City of Puyallup
Development
Engineering
APPROVED

EAST TOWN CROSSING
BUILDING 'E'
PIONEER & SHAW PUYALLUP, WA

DRAWN BY: BL / CM
CHECKED BY: BL
DATE: 24.03.11
TITLE: SITE PLAN - REF ONLY
PROJECT #: 2016
SHEET:

AS1.0

4 OVERALL SITE PLAN - PHASE 2
SCALE: 1" = 40'

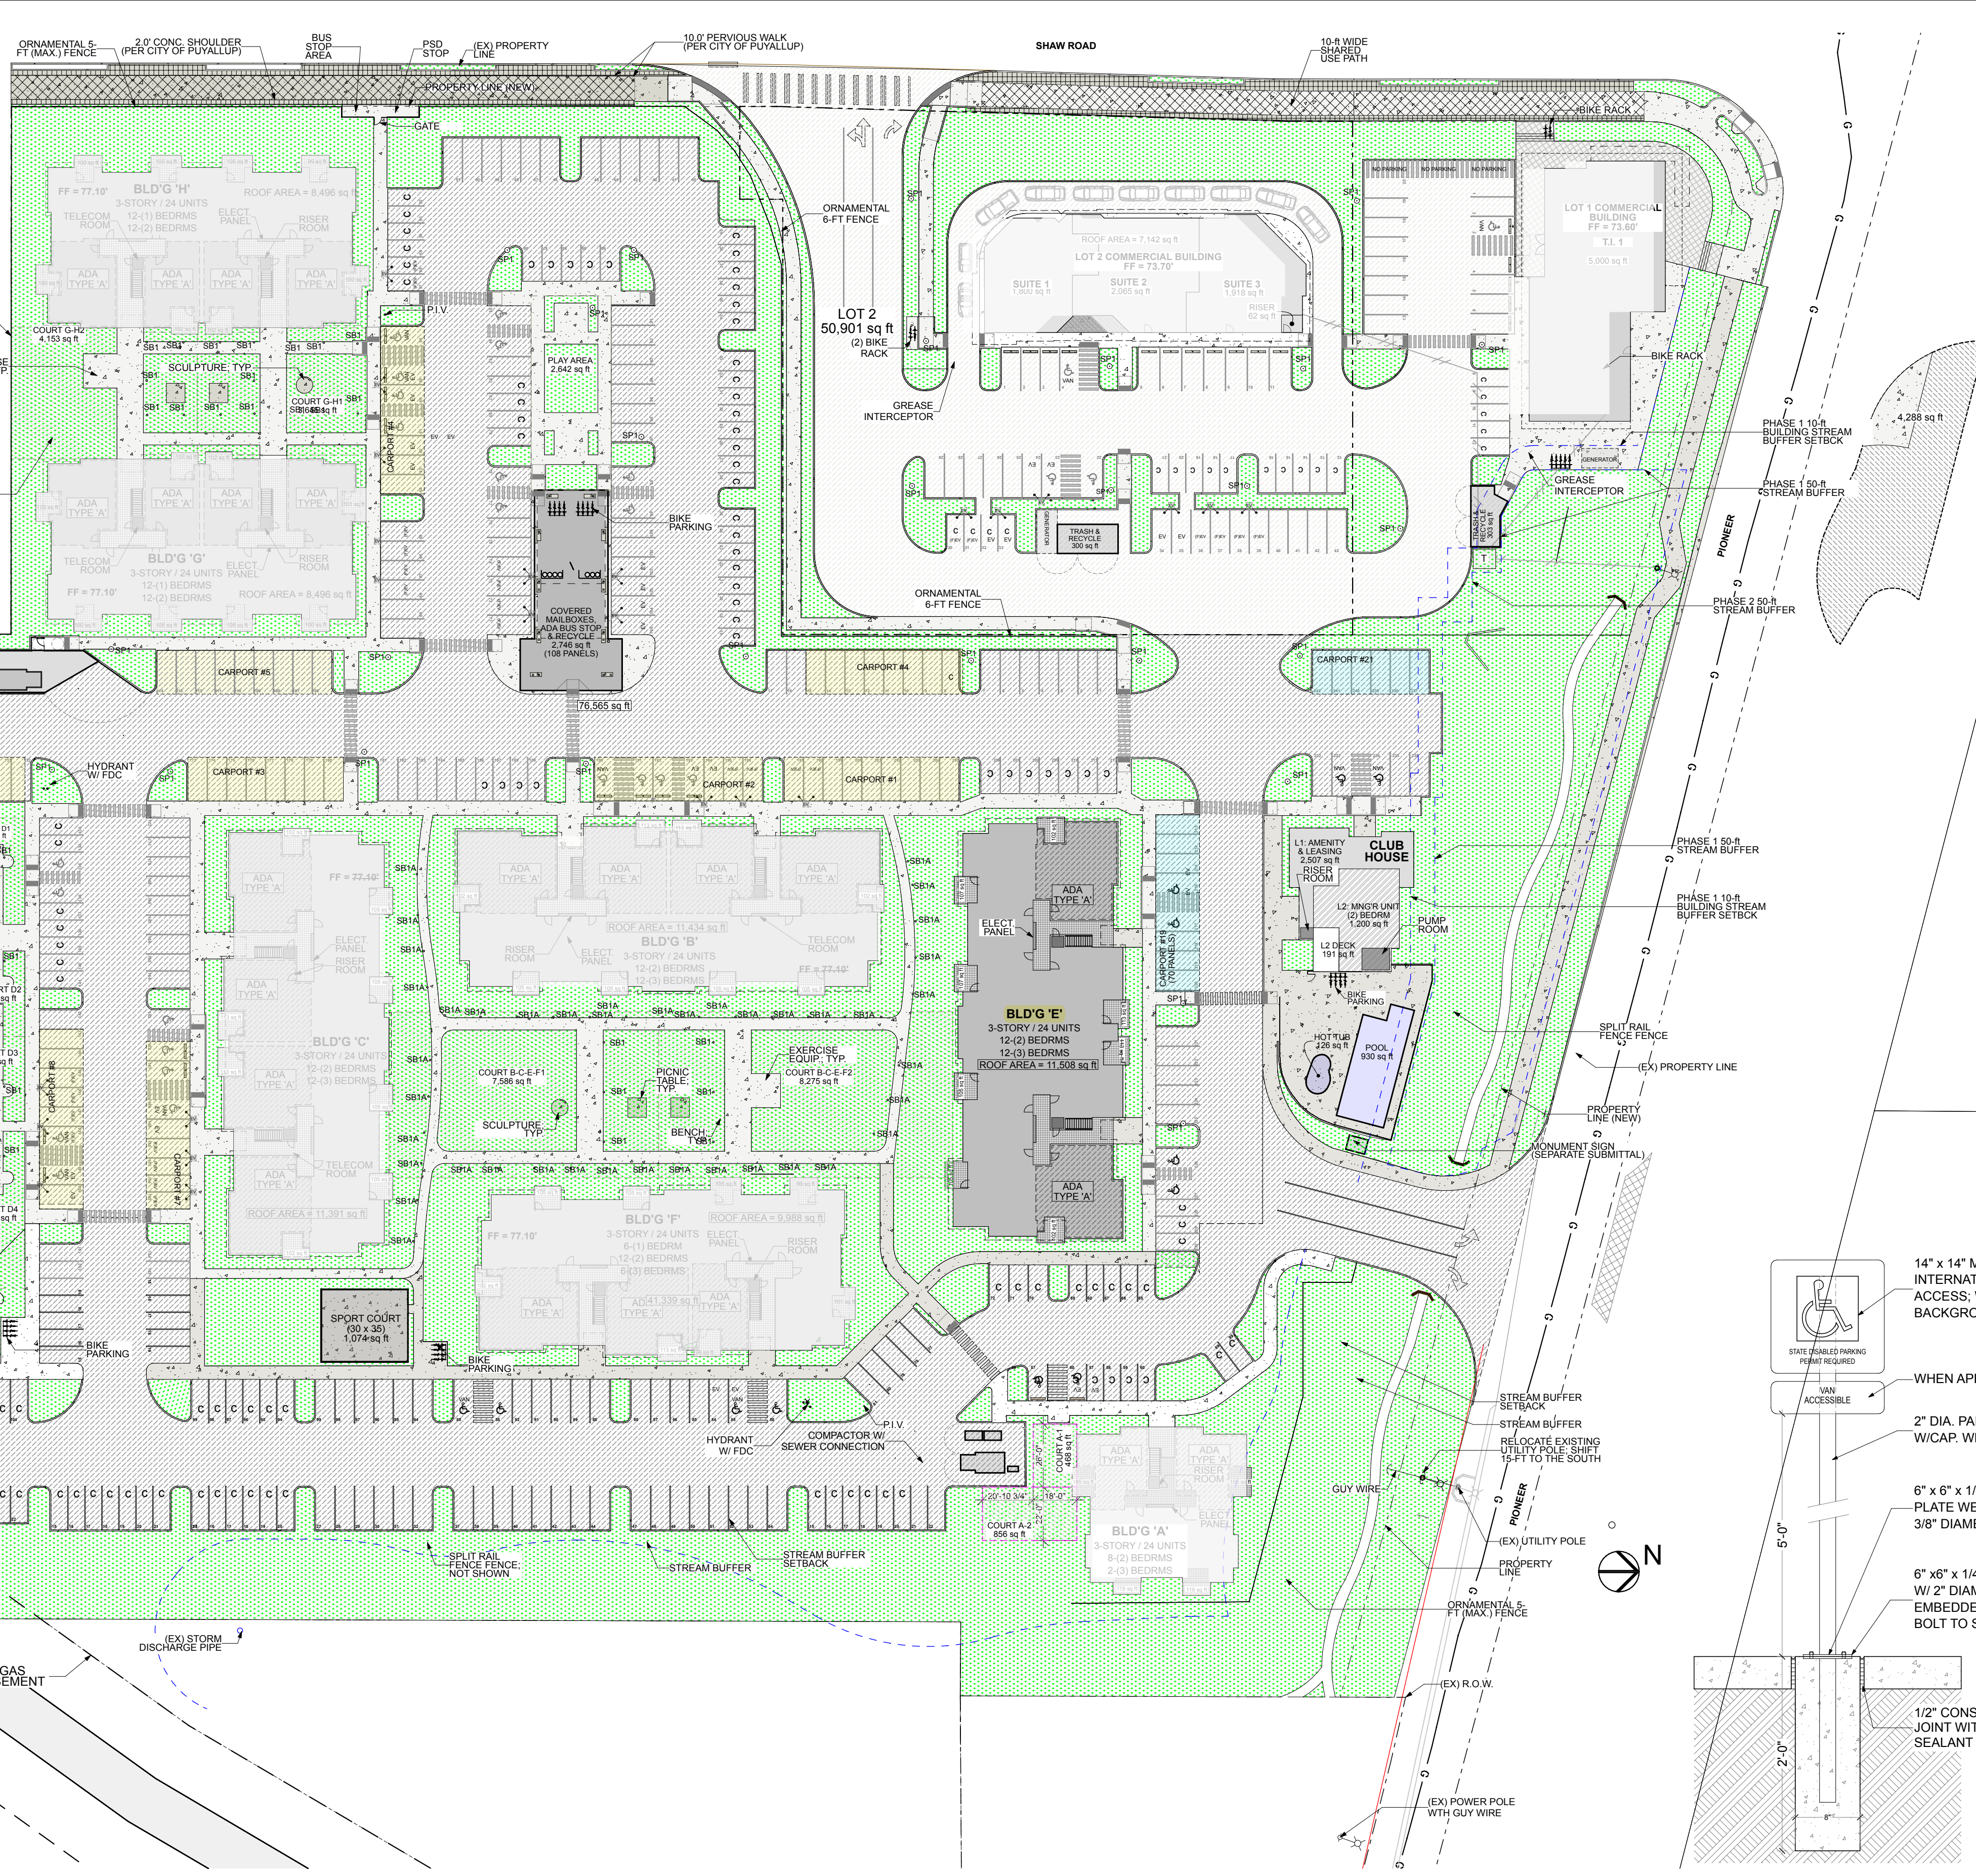
The applicant shall request a sediment control and erosion inspection with a City Engineering Inspector through the CityView portal at least 48 hours in advance of job start. Refer to the Stormwater Fact Sheet and City Standards 02.03.02 & 05.02.01

Sediment control and erosion procedures shall be practiced eliminating and preventing off site damage. Stormwater runoff originating upgrade of exposed areas shall be controlled to reduce erosion and sediment loss during the period of exposure. See civil permit PRCCP20230970 for specifications

Roof downspout control is required. Steps shall be taken to prevent drainage onto adjacent lots. See civil permit PRCCP20230970 for specifications

TYPICAL AT EACH APARTMENT BUILDING
A stand of trees with a canopy of 1,000 square feet (as measured in frontal view rather than top view) located no farther than 20 feet from a facade of the building, consisting of either existing trees, or planted trees.
(Per PMC 20.26.200 (4) (b) (v))

The applicant is responsible to show onsite private utilities services for each building on a site plan. This includes sewer or septic, storm and water. [Site Plan Sheet 1 of]
